Office Action Summary	Application No. 10/595,615	Applicant(s) RAND, PAUL KENNETH	
	Examiner CELENE MOORER	Art Unit 4138

DETAILED ACTION

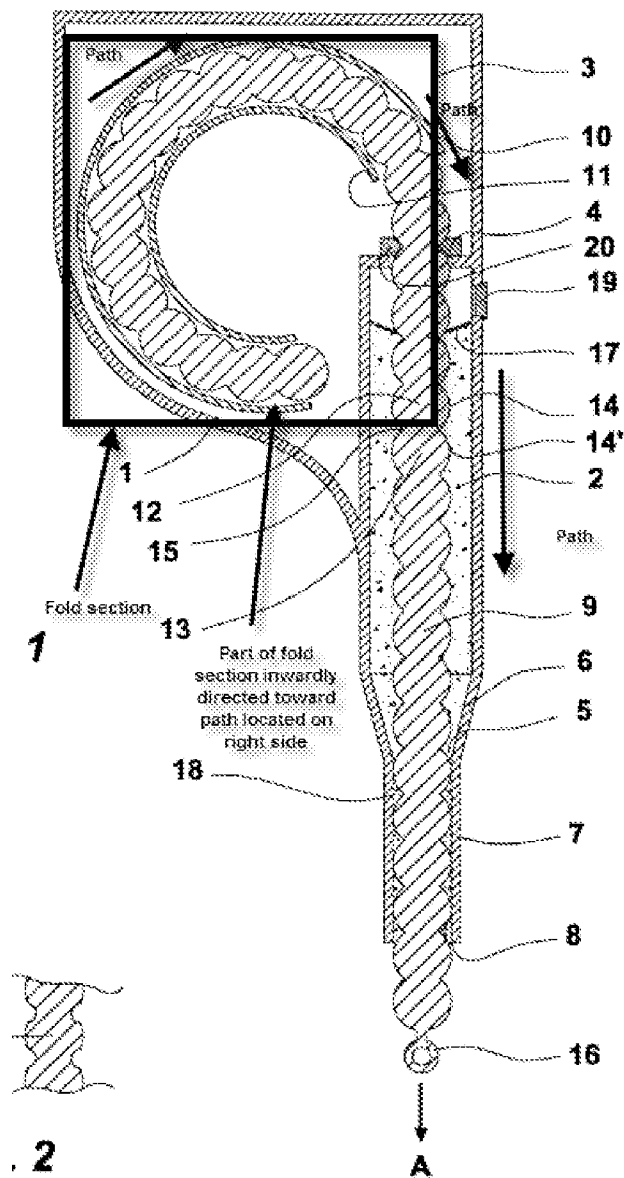
As to claim 4, wherein the at least fold section is inwardly directed towards another section of the path (see Figure below).

As to claim 5, a track wherein the at least one fold section is a loop section in the path (see Figure above).

As to claim 6, wherein the loop section is an inverted, generally U-shaped section (see Figure above).

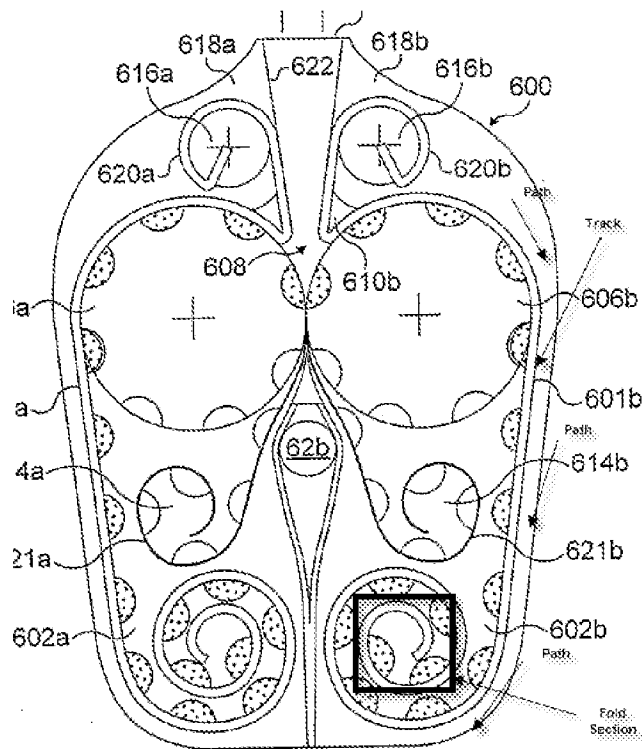
As to claim 15, in which the capsules are linked together to form the chain (see Figure above).

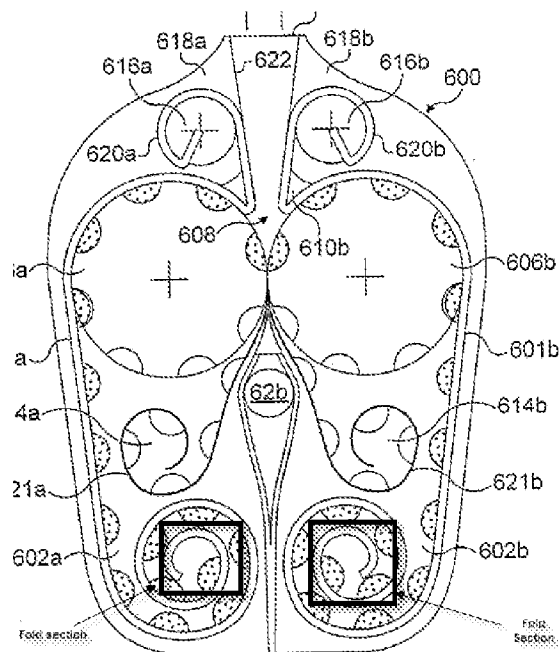
As to claim 3, a track wherein the at least one fold section is inwardly directed (represented by track 601a and 601b that in the lower part of the left chamber 602a and right chamber 602b).

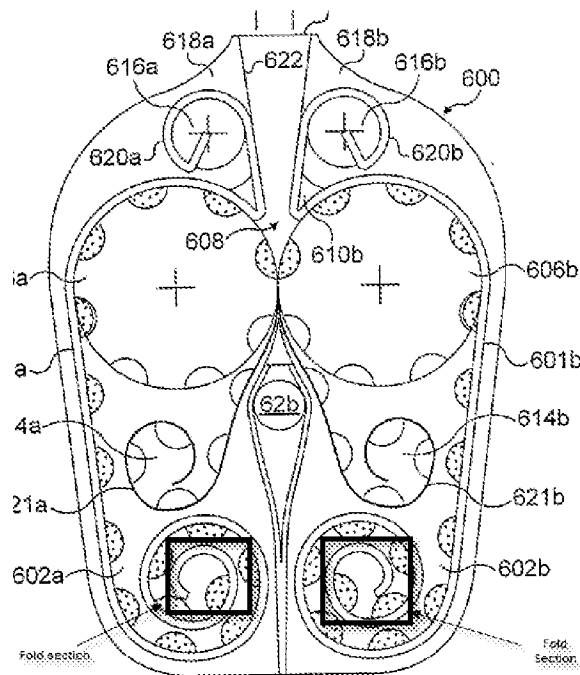
As to claim 5, a track wherein the at least one fold section is a loop section in the path (Figure 6a, fold section seen in the lower part of the left chamber 602a and right chamber 602b has a loop section).

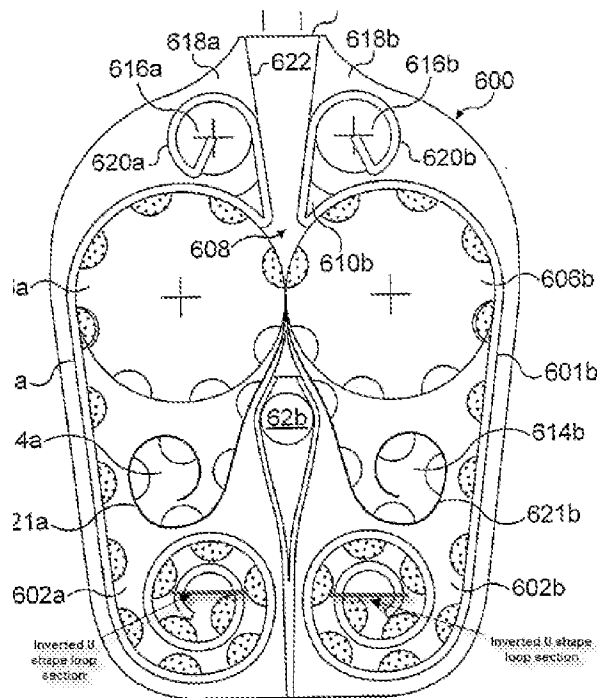
As to claim 6, wherein the loop section is an inverted, generally U-shaped section (see Figure below).

As to claim 7, wherein the path has a pair of opposed side sections extending from first ends thereof generally in a first direction and a second side section extending generally transversely to the first direction to connect the respective first ends of the first side sections wherein the at least one fold section is in the second side section and has a pair of opposed first side portions which extend generally in the first direction, the at least one fold section being directed such that each first side portion is in facing relation with a different first side portion (see Figure below).

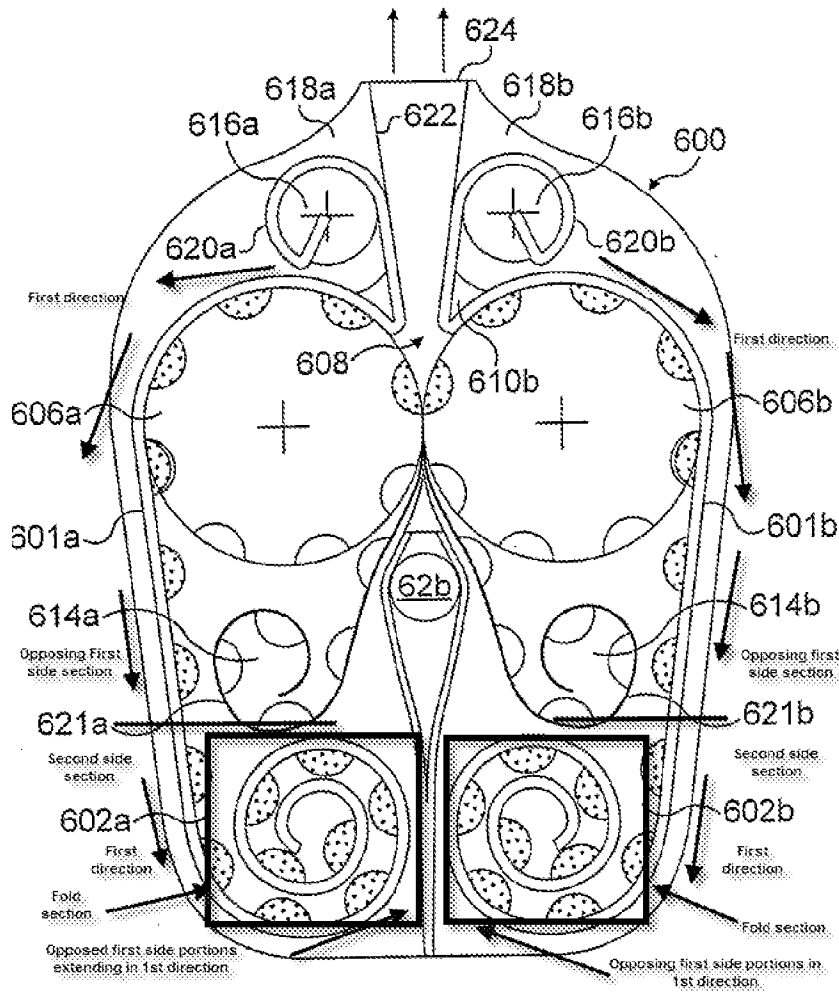
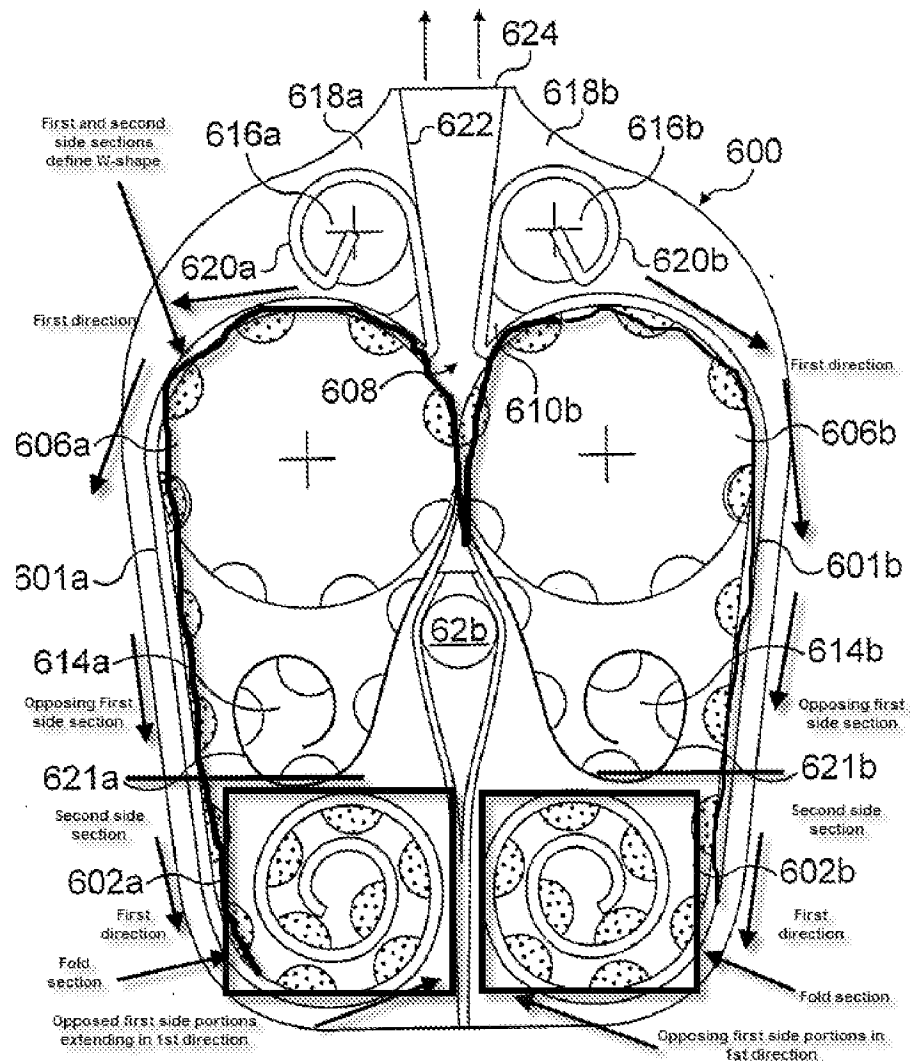
As to claim 8, wherein the first and second side sections define a generally W-shape when viewed in plan.

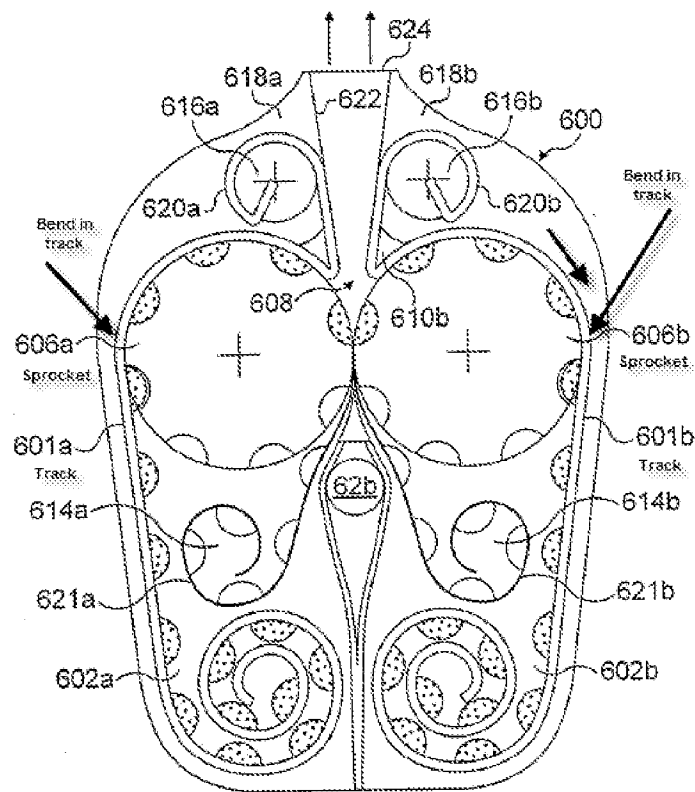
As to claim 22, wherein the at least one sprocket is located at a bend in the track for engaging the capsules for advancement thereof along the track (Figure 6, 606a,606b) (See below).
